ADDENDUM

Project:	Bear Creek Fire Station	Addendum # 02
Owner:	Onslow County	
Owner ID No.:	Bid No. 102-25C	
DKA Project No.:	2324	
Prepared By:	Alexandre Penegre	
Bid Documents Issue Date:		4/22/2025

C1 FLOOR PLAN - LEVEL 1
1/8" = 1'-0"

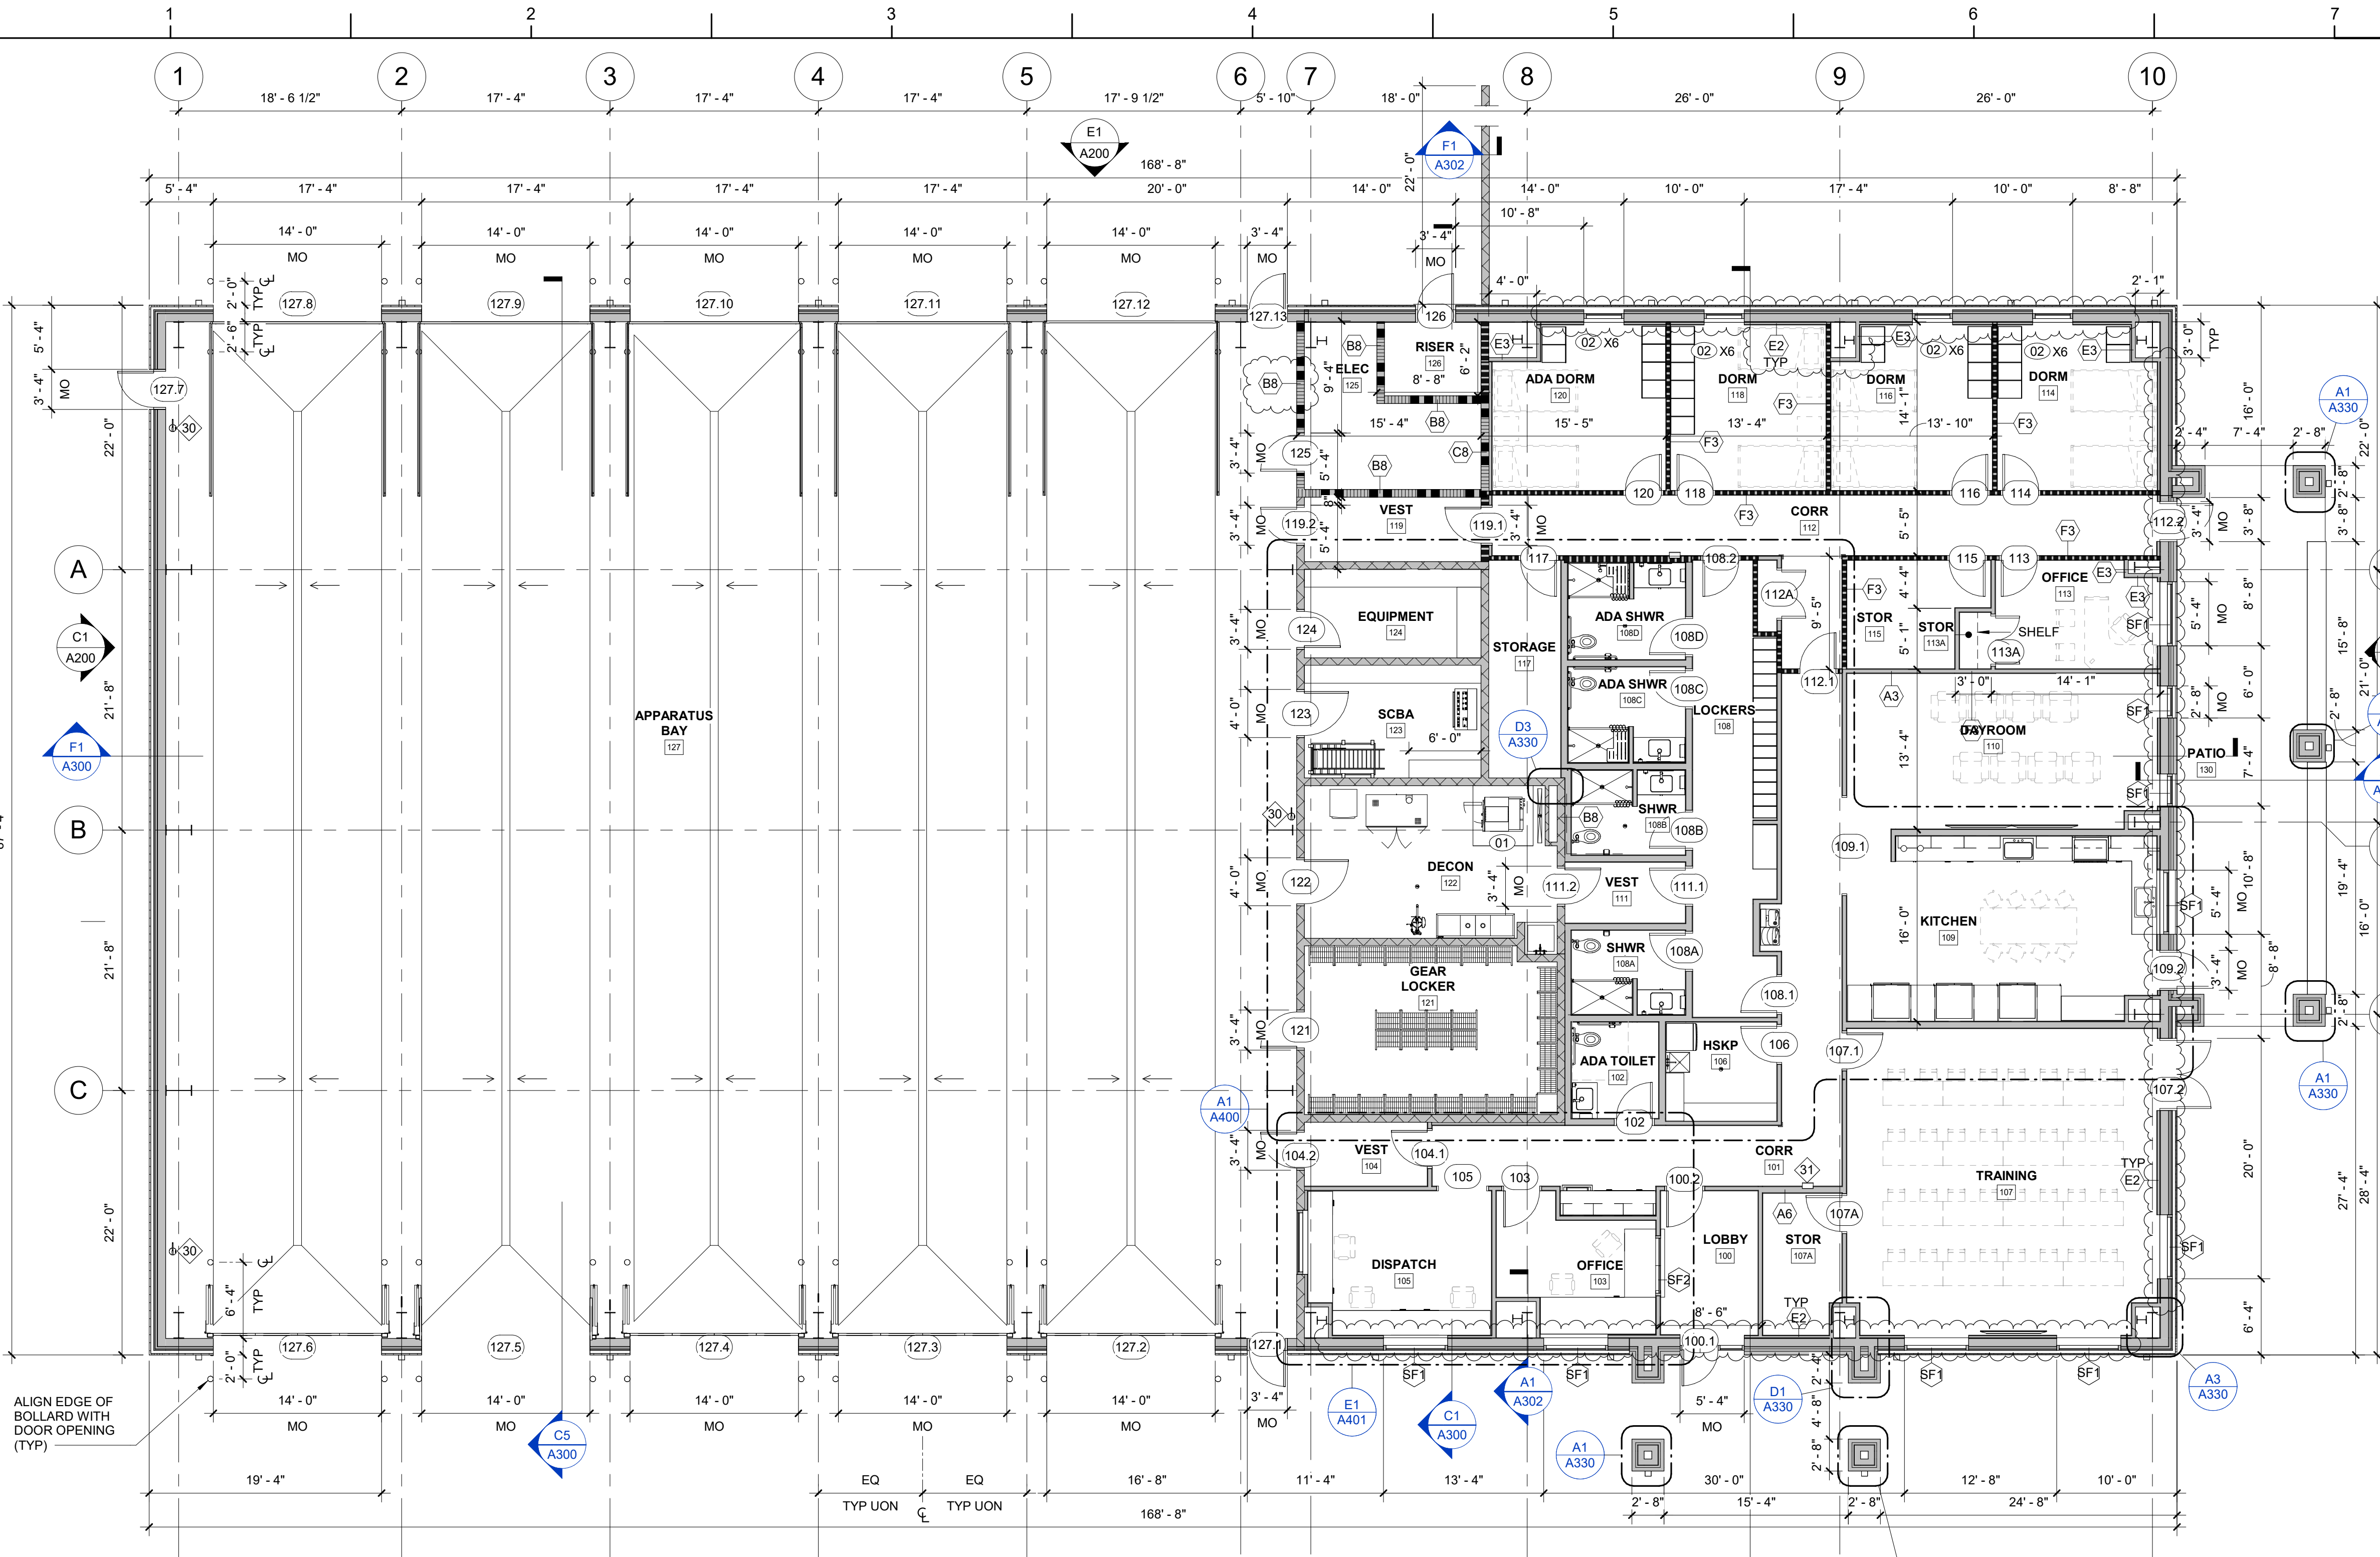
17. Drawing C903
 - a. Revised details
18. Drawing A002
 - a. Revised to include types D3 and E2 to the Partition Legend.
19. Drawing A100
 - a. Revised to include partition type E2 along exterior wall of Business and Dorms.

- b. Revised Equipment Platform walls to be A6 above CMU wall (starting 12'-0" AFF).
20. Drawing A110
 - a. Revised to show location of horizontal blinds and combination roller shades.

G1 EAST ELEVATION
3/32" = 1'-0"

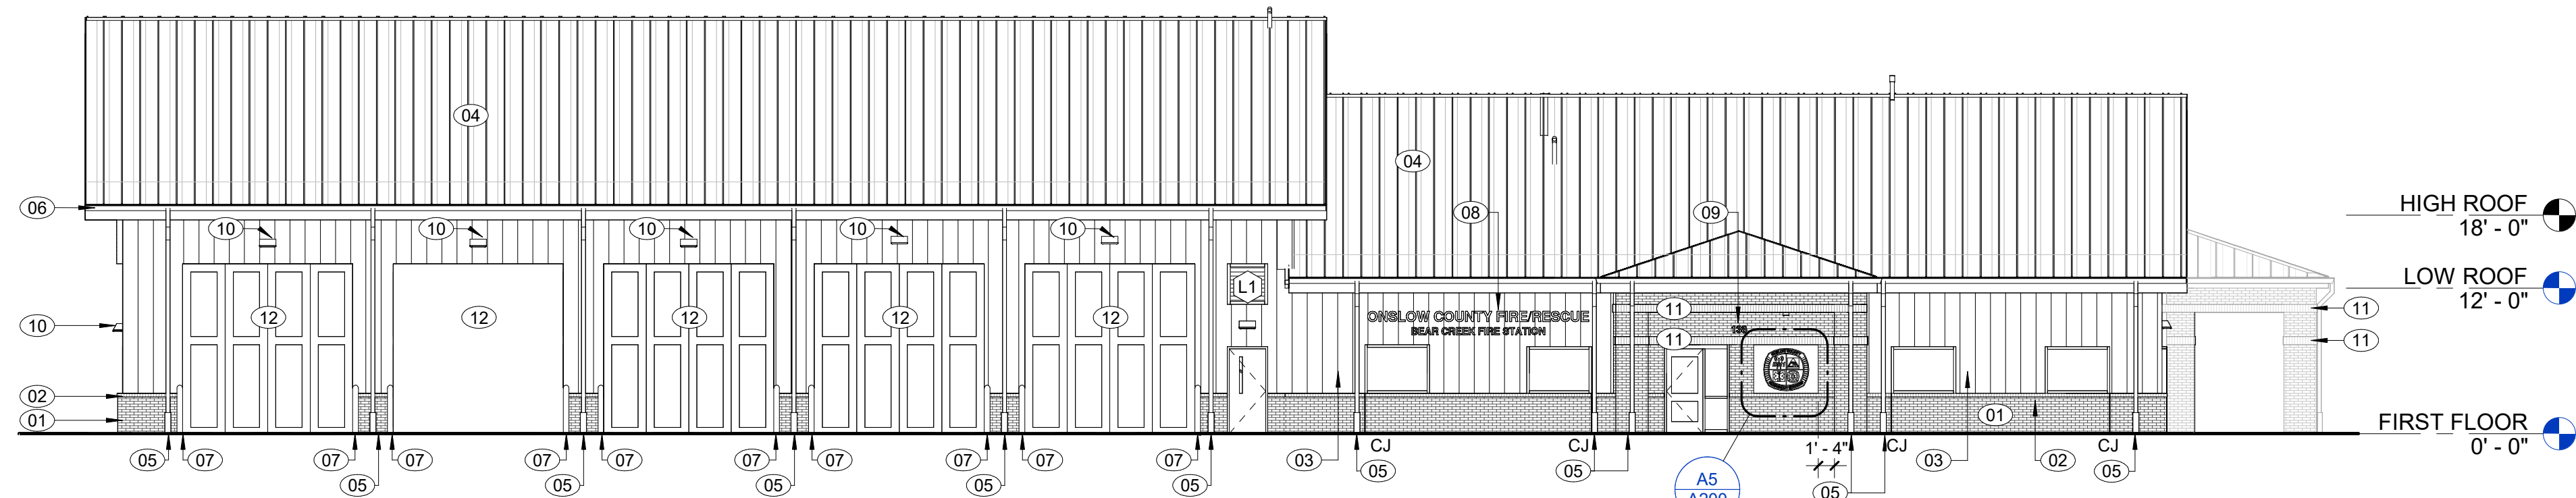
- a. The design intent is for the sign to be a wet-poured cast stone.
12. Sheet A200 also has letters illustrated in Detail G1. The Key Notes call those out as being a Century Gothic font but Spec 2.1 A. 6. calls them out as being Helvetica. Which font is preferred?

- a. Helvetica font is preferred. The keynote on A200 has been revised to match the specification.
13. Spec 101419 2.1 A. 1. Notes that the letters on Sheet A200 are to be cast aluminum. My concern is the length. If I scaled it correctly, the overall length of the sign as illustrated is 205 ½". The font illustrated is a condensed version of a block font that may or may not be a Century Gothic. There are many printed versions available online but the only CAST version that I'm aware of is NOT condensed meaning that it won't fit in that 205 ½" length limitation. To be able to hit that length at the required heights in the font as illustrated, I know of a few options:

21. Drawing A200
 - a. Revised keynotes O8 and O9 to "Helvetica" font.
22. Drawing A300
 - a. Revised to include partition type E2 along exterior wall of Business and Dorms.

A1 WALL SECTION - APPARATUS BAY WEST
1/2" = 1'-0"

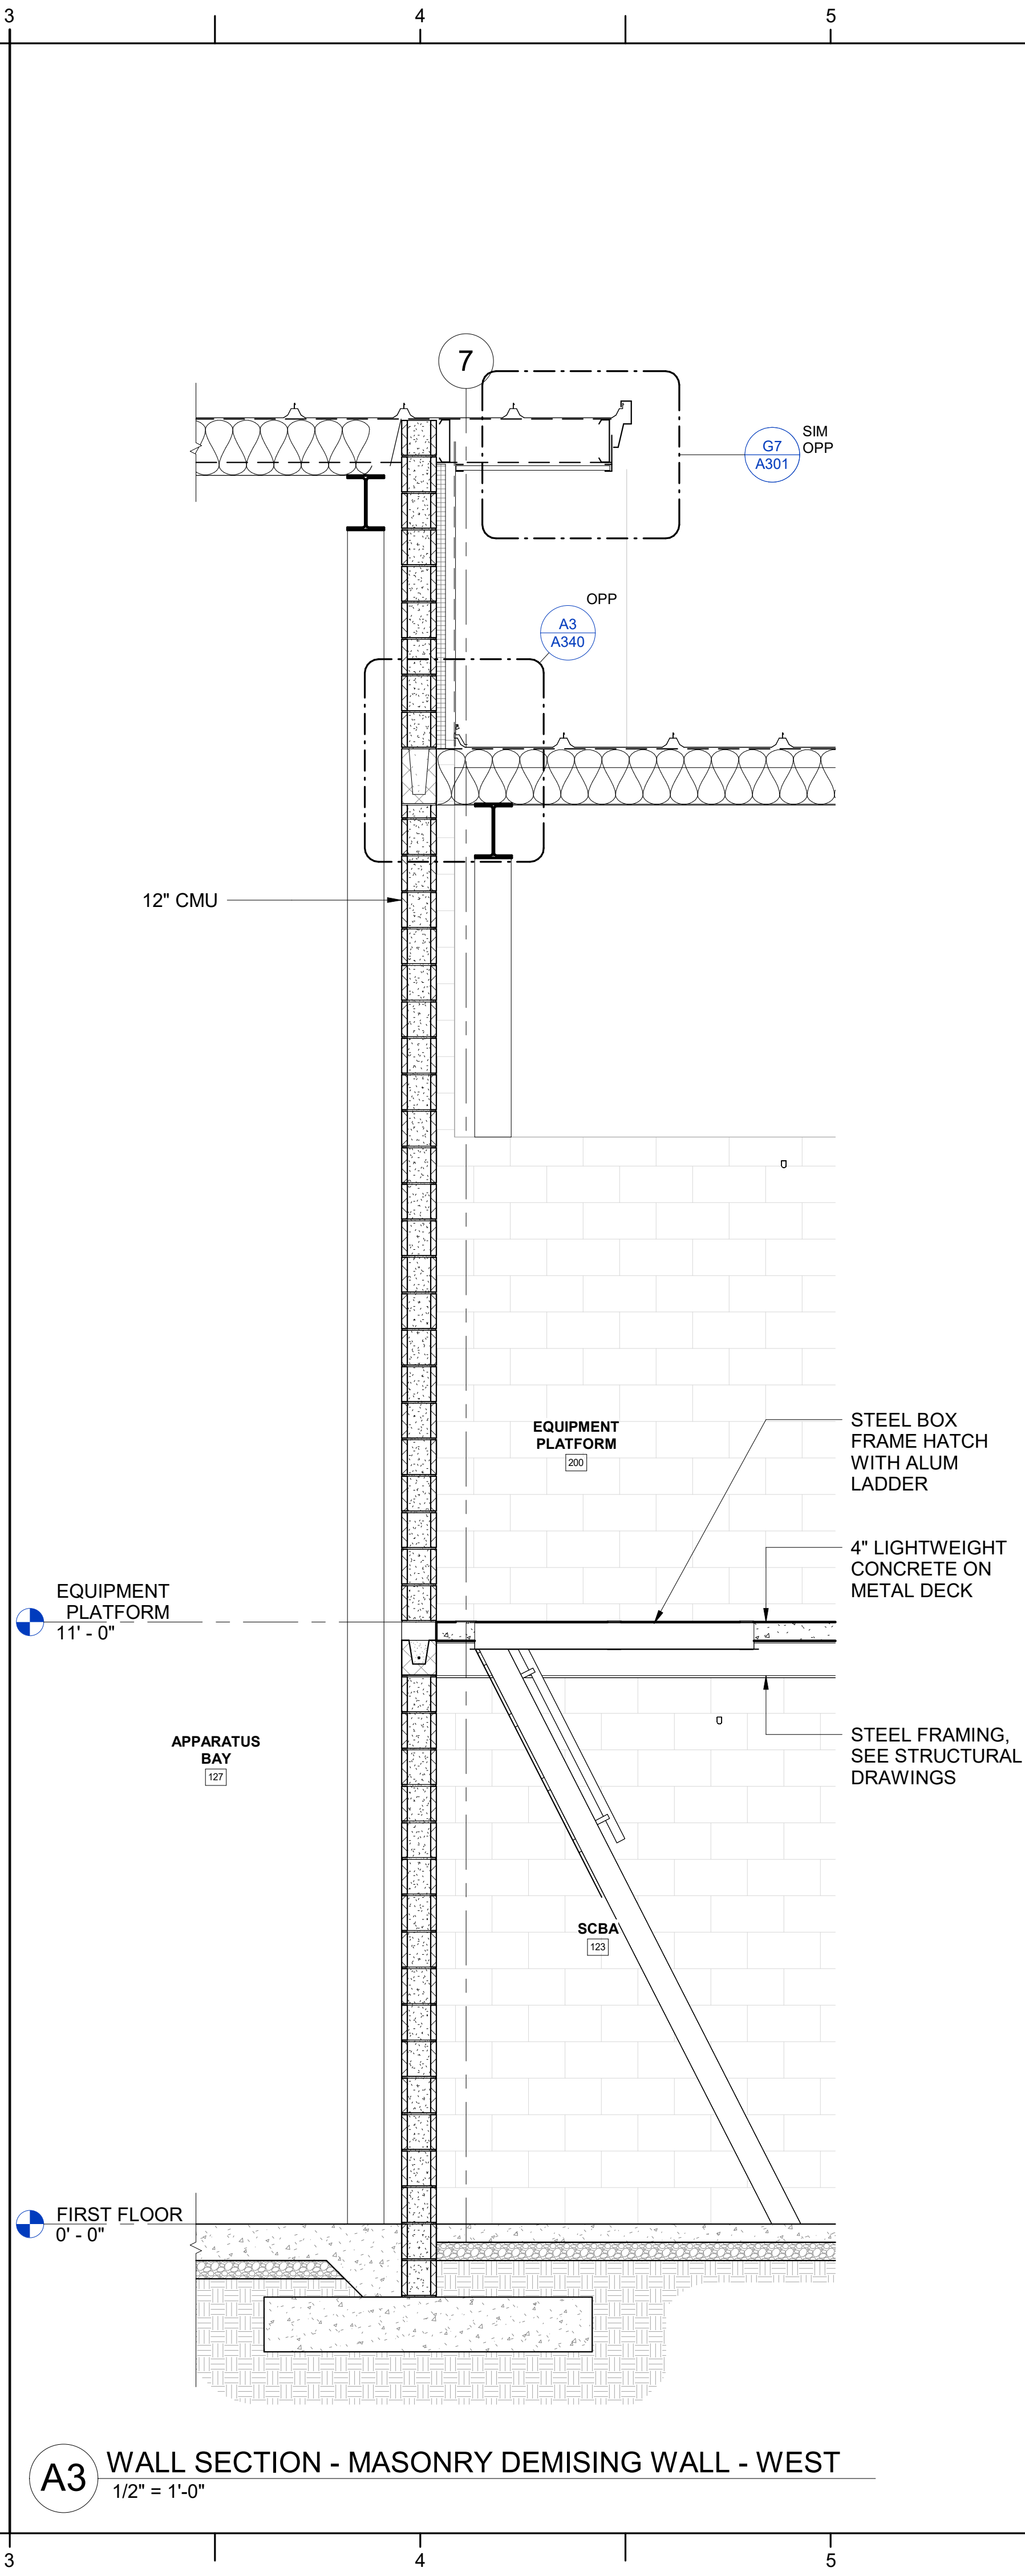
- b. Revised Equipment Platform wall above CMU to be type A6.
23. Drawing A301
 - a. Details A1, A6, and G7 revised to remove sheathing, rigid insulation, and air barrier where metal panel is called for.
Provide PEMB thermal blocks at each girt. 8" metal studs added where brick is called for.

A3 SECTION DETAIL - LOUVER SILL @ PEMB/METAL PANEL
3" = 1'-0"

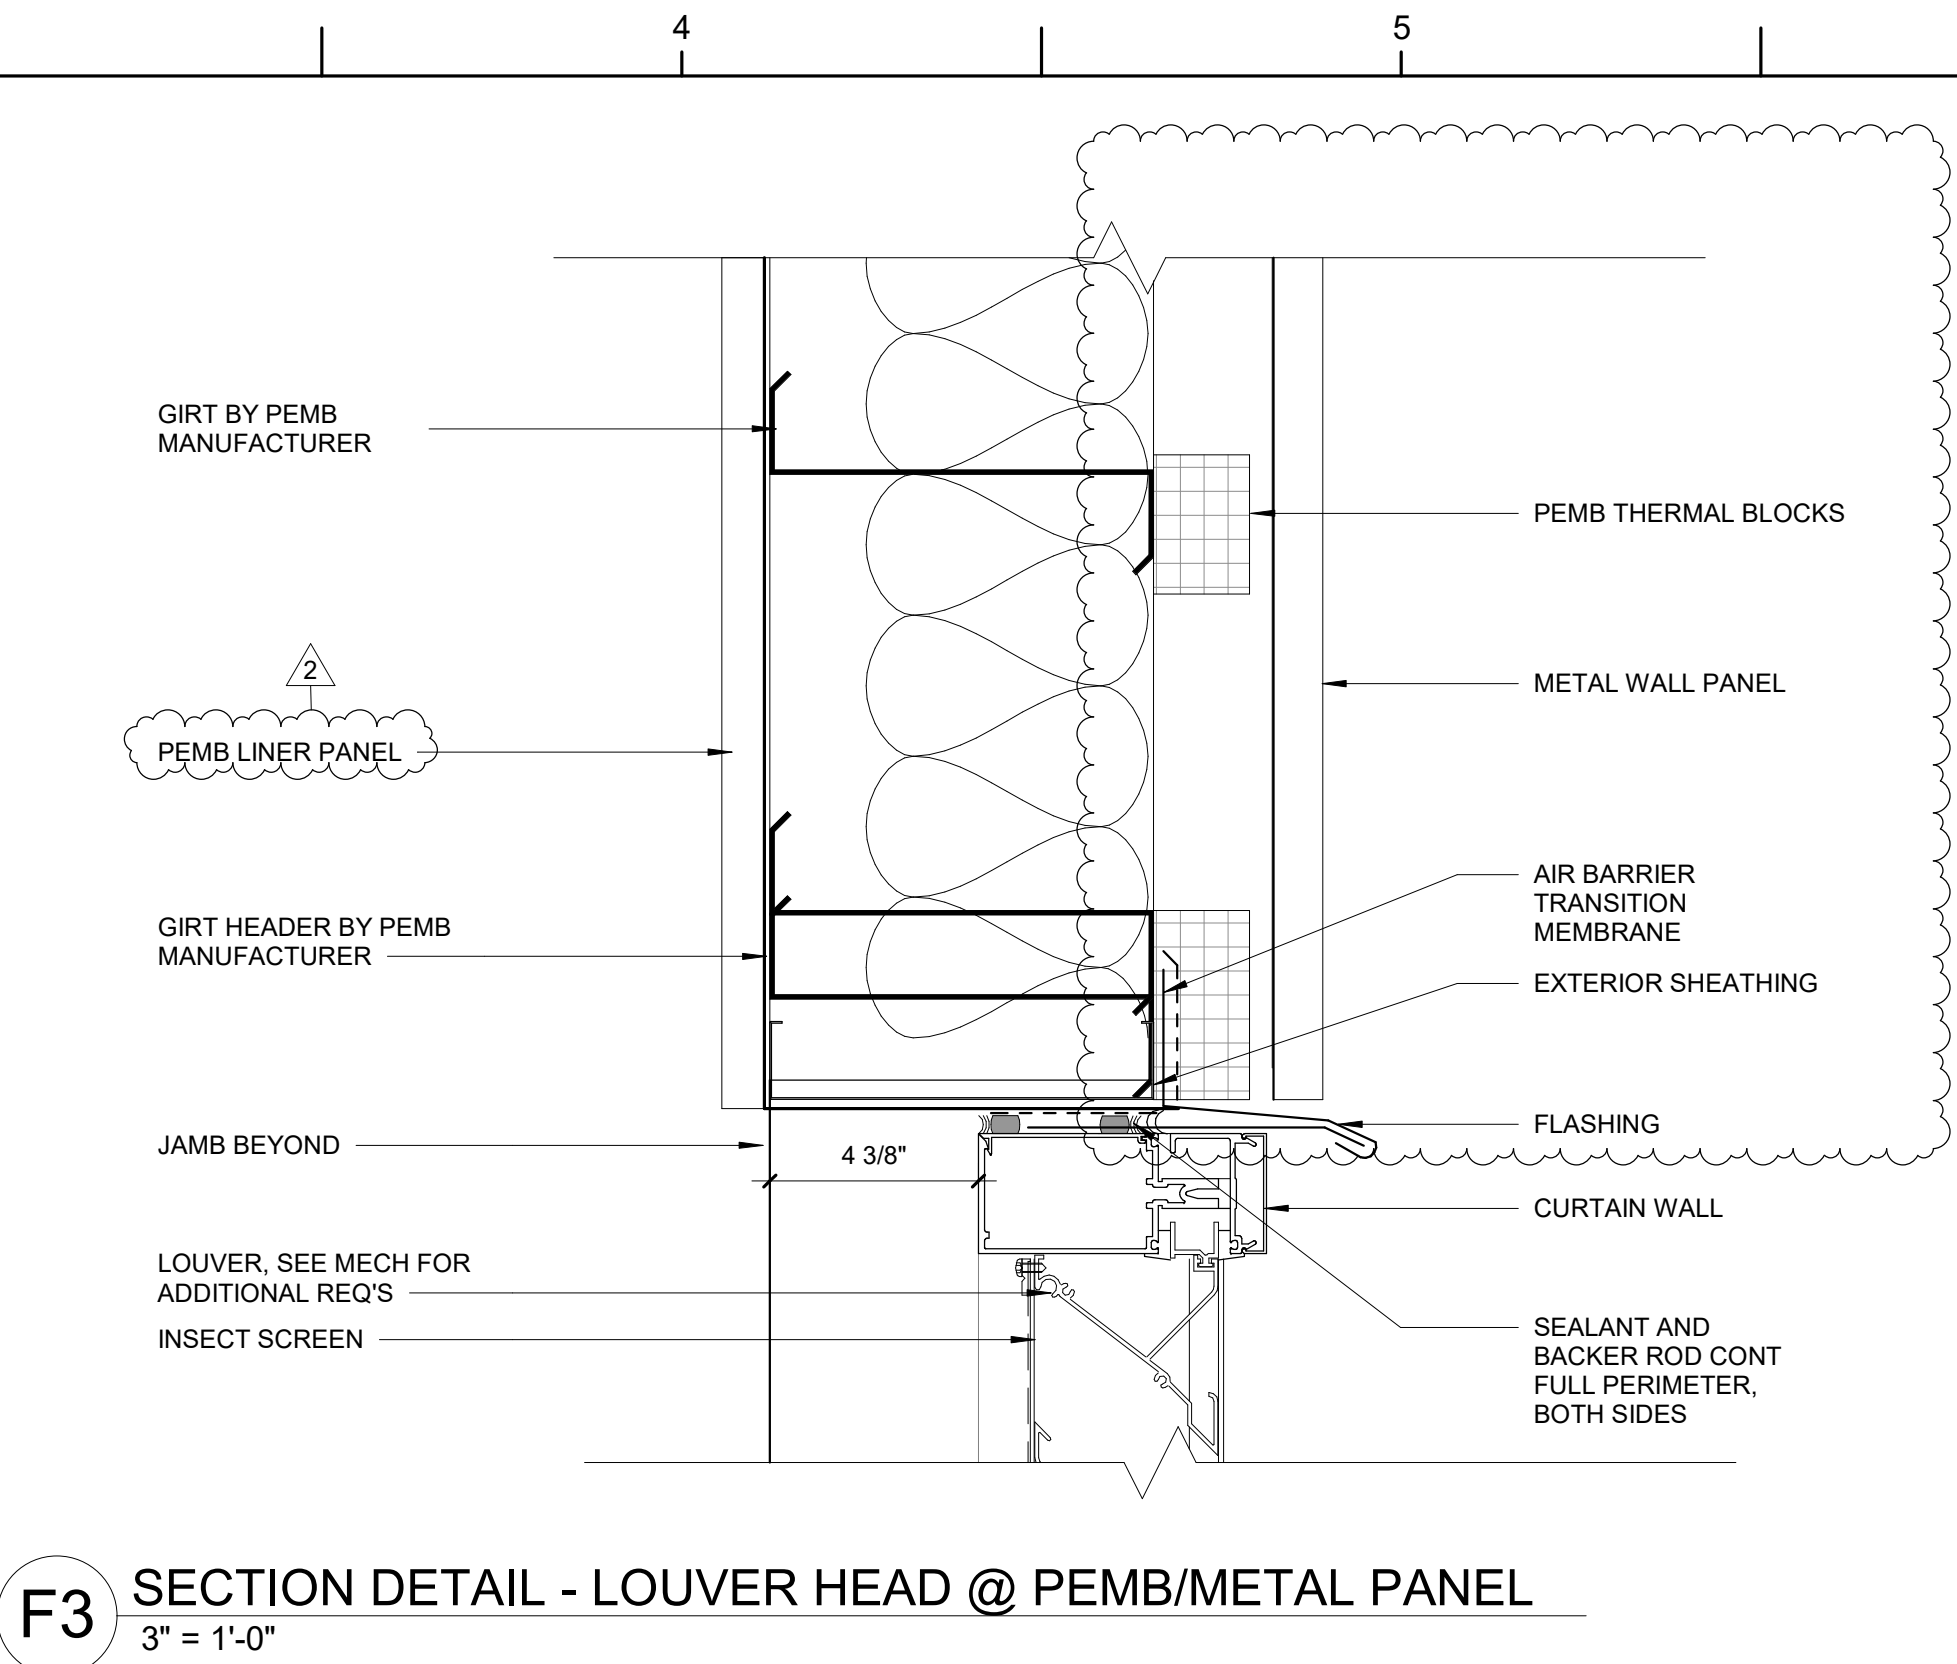
32. Drawing A702
- a. Details F3, C3, A3 revised to remove sheathing, rigid insulation, and air barrier where metal panel is called for. Provide PEMB thermal blocks at each girt.
